| Title | Enhancement of TRF-IND Signaling |
| Re: | Contribution on comments to IEEE P802.16e/D4 |

Enhancement of TRF-IND Signaling

Figure 1. Description of the case of the MSS missed the TRF-IND message, but the BS transmitted the DL buffered data.

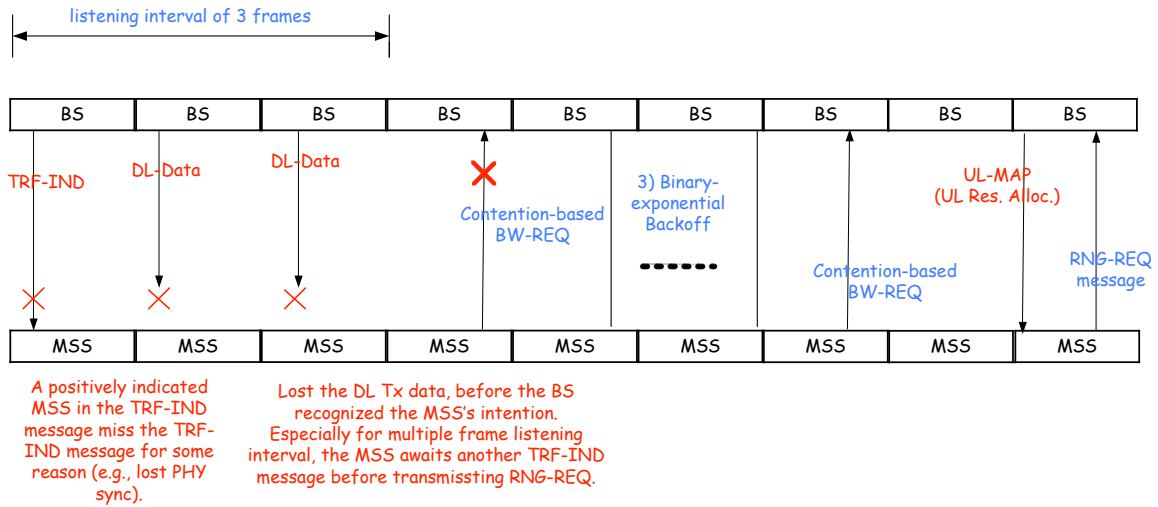
And, the current TRF-IND signaling has no acknowledgement. When the MSS misses the TRF-IND message in the corresponding frame due to a certain reason, the BS can transmit the DL buffered data to the corresponding MSS even during the frame in the listening interval. In that case, the downlink data shall be lost and later be retransmitted after the MSS re-entering to the normal operation states. It also wastes up precious air resources, so we need a resolution to the problem.

We described the problem situation in Figure 1 and Figure 2.

Therefore, we propose to enhance the TRF-IND signaling to resolve this problem with a minimum signaling overheads. We propose to add the indication information for fast UL feedback channel allocation in TRF-IND message for the positively indicated MSS's. For the BS-MSS which is operated in CQI-based mechanism, we can allocate the appropriate CQI channel to the corresponding MSS. And, for the non-CQI-based BS-MSS, we can apply the invited ranging interval for the MSS which can report its preferred DIUC.

The MSS which has allocated its fast UL feedback channel or invited ranging interval should respond with its CQI report value or preferred DIUC value to the corresponding BS. Therefore the BS can recognize it as the acknowledgement signal for the TRF-IND message and can transmit the buffered DL data to the MSS with the appropriate DIUC (AMC-level).

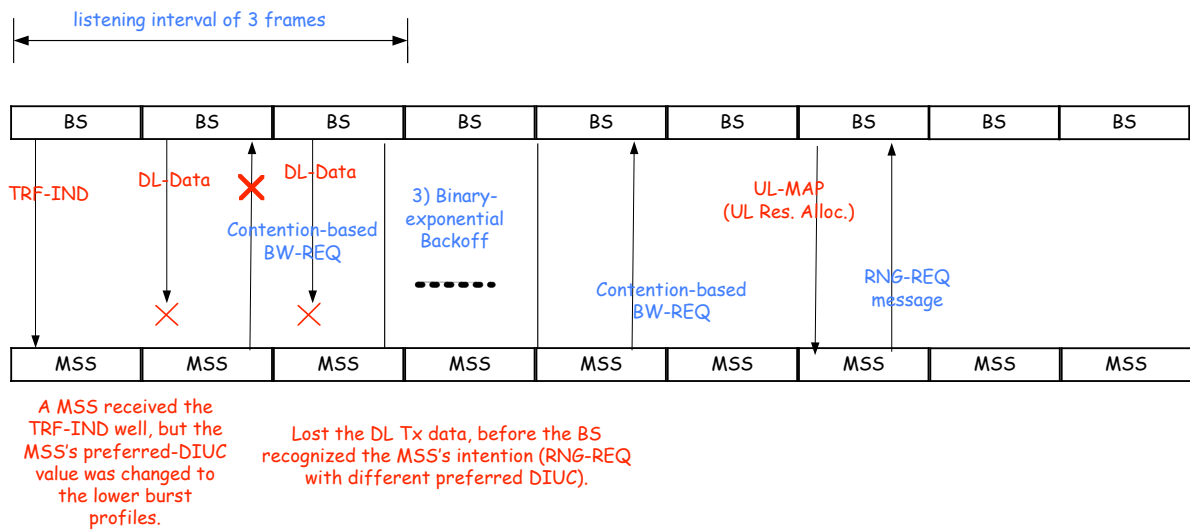
Due to the current P802.16e/D4, the BS may transmit DL buffered data addressed to the sleep mode MSS anytime after the positive TRF-IND signaling. But the MSS's DL channel characteristics (e.g., appropriate DIUC level) can be largely different from that of the sleep mode entering time. If we apply the periodic ranging during the sleep interval instead of it especially reduces power saving efficiency, we can reduce the problem, but not clearly solve them. Generally, the periodic ranging interval have the scale of few hundreds msec. And, during that interval we can adjust the appropriate timing offset due to the movement of the MSS, but it is not possible for power adjustment correctly. Since the coherence time is the order of up to few msec even in the pedestrian speed, so we cannot guarantee that we can apply the same DIUC adjusted in the last periodic ranging event at the midst of the periodic ranging interval. (*Coherence time has the time of meaning of the channel condition is the same, which have the difference in the SNR value is less than 3 dB. Remember that the difference in the neighboring DIUC levels is about to 3dB or less.*) But, the shorter time interval as the periodic ranging gives us more signaling overheads and it reduces system performance.
